PROJECT
191 MARGINAL WAY
RETAIL CENTER
191 MARGINAL WAY
PORTLAND, MAINE 04101

DRAWING
STOREFRONT & DOOR
ELEVATIONS
CWS PROJECT NUMBER: 15.063

REVISIONS	DATE
ADDENDUM 01	02/21/2017

DRAWING NUMBER
A8.01
SCALE: AS NOTED
DATE: 02/10/2017

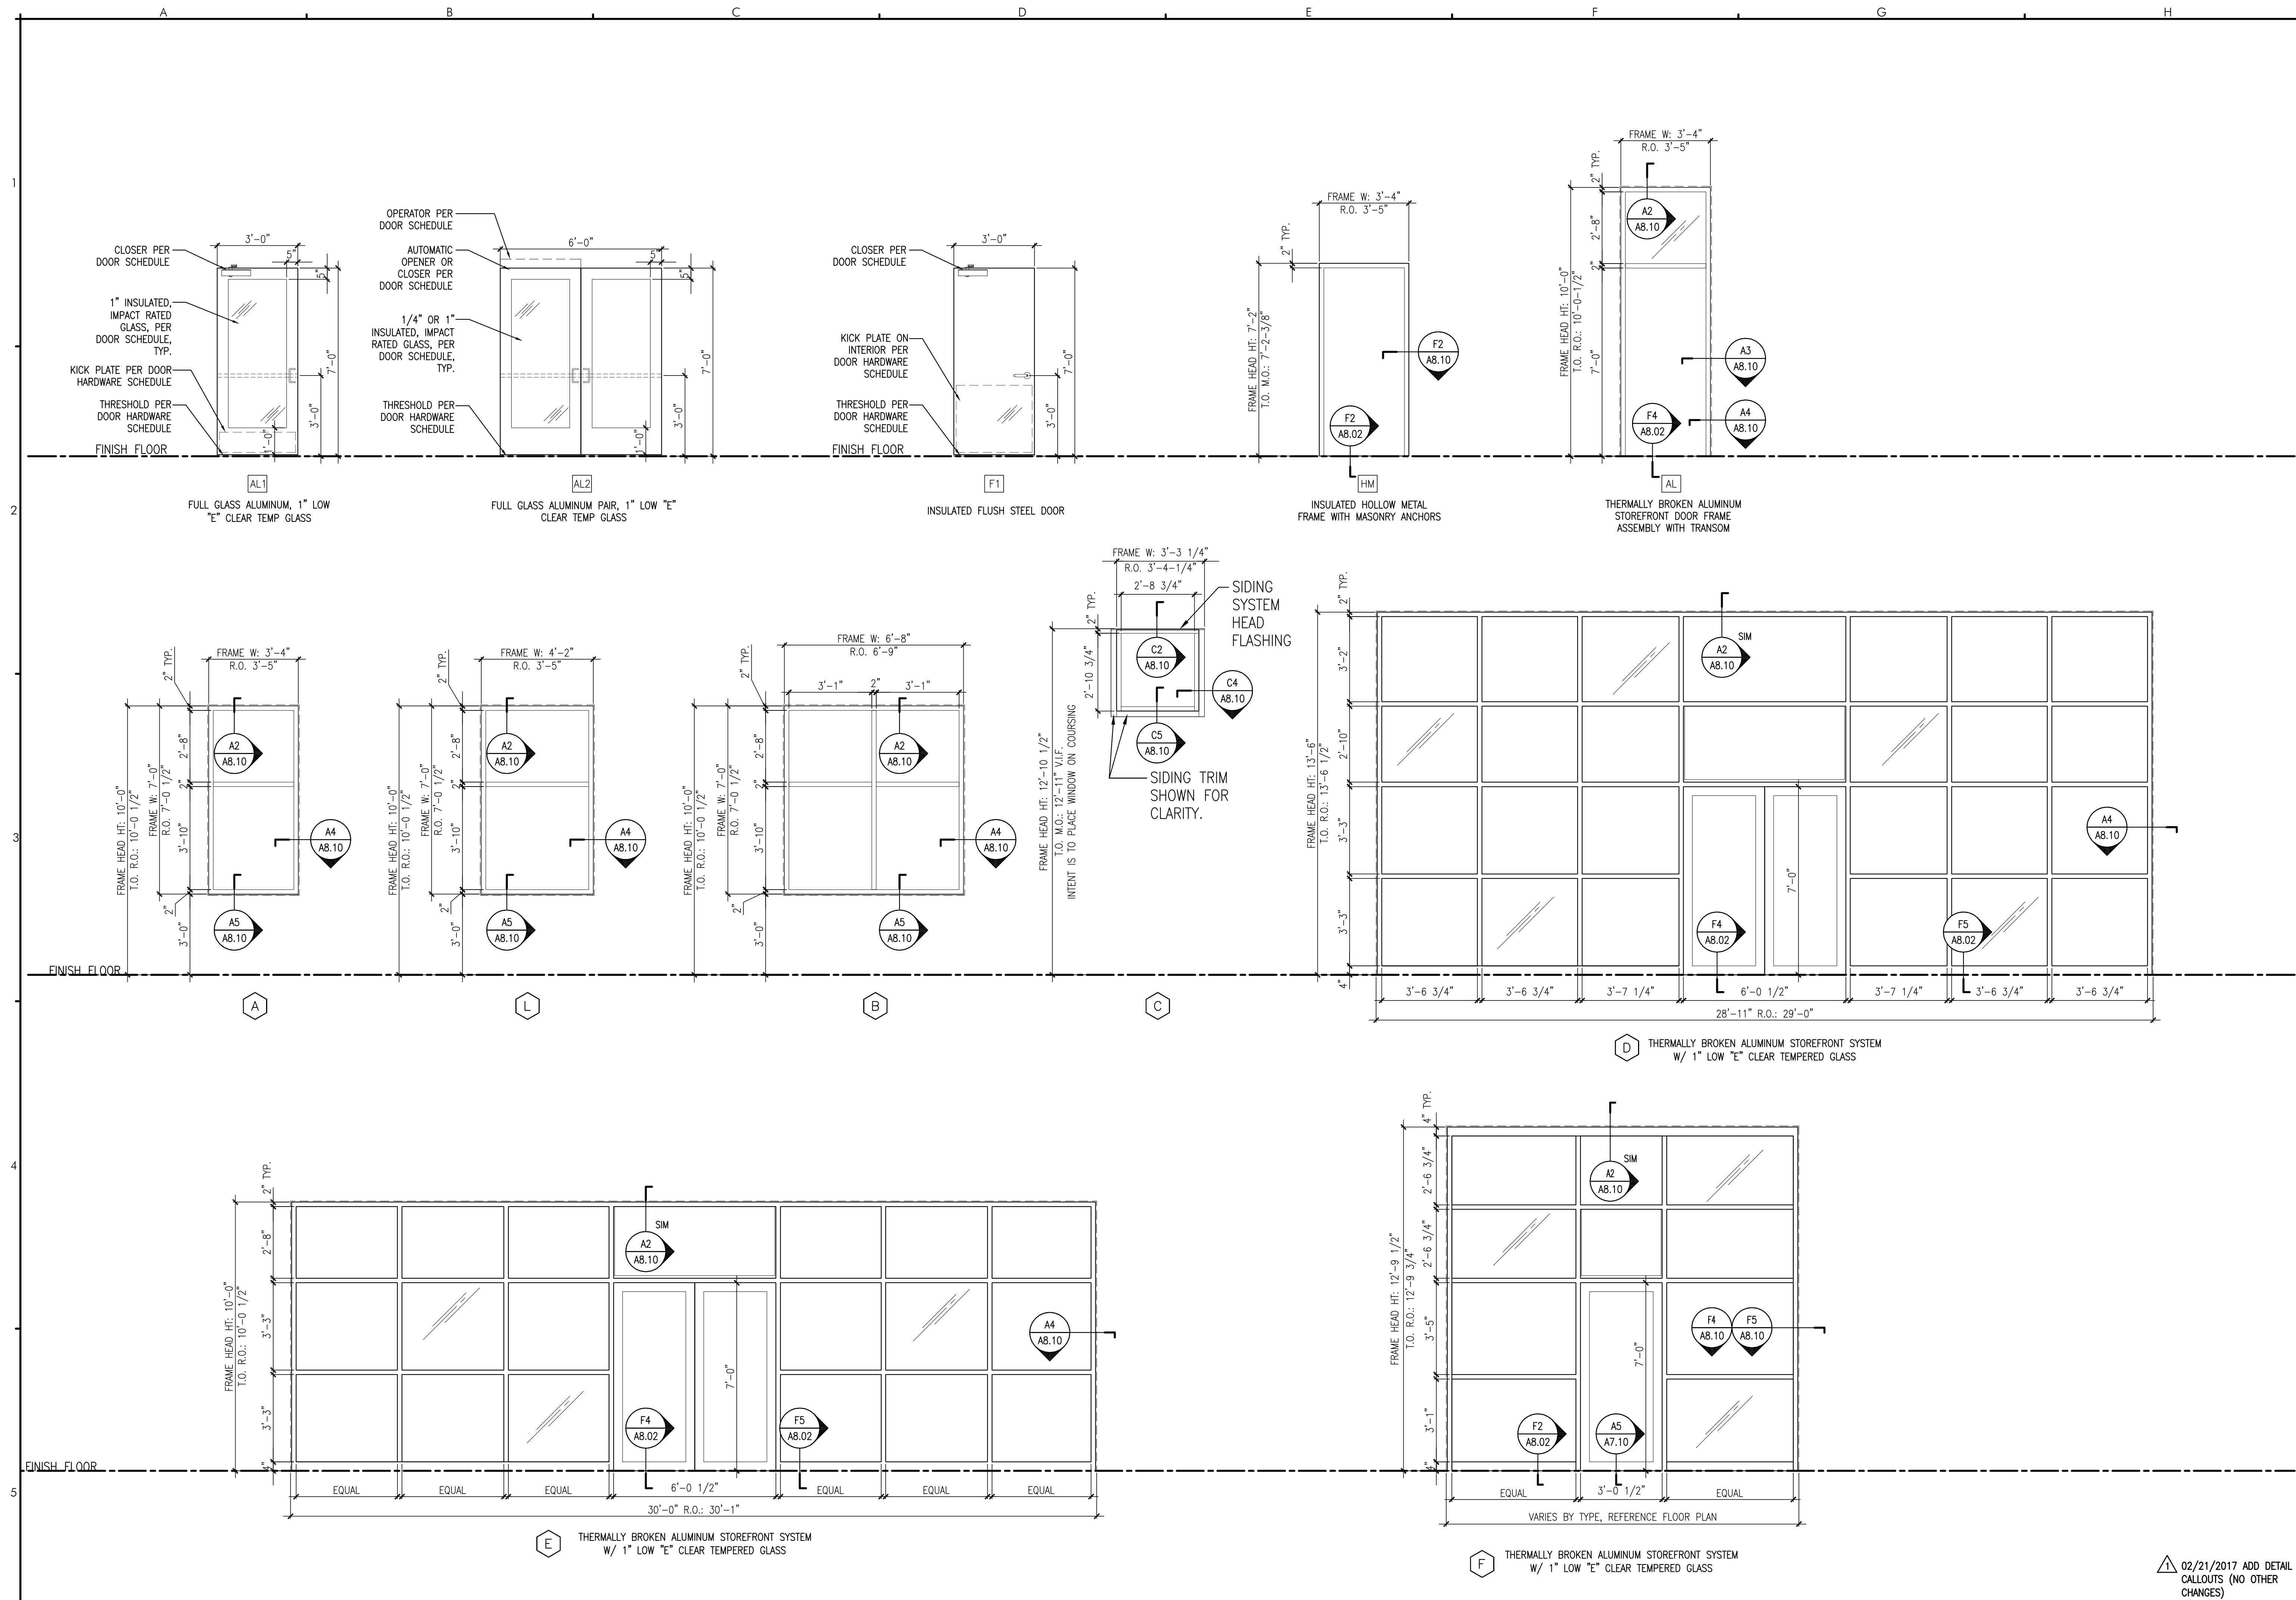
02/21/2017 ADD DETAIL CALLOUTS (NO OTHER CHANGES)
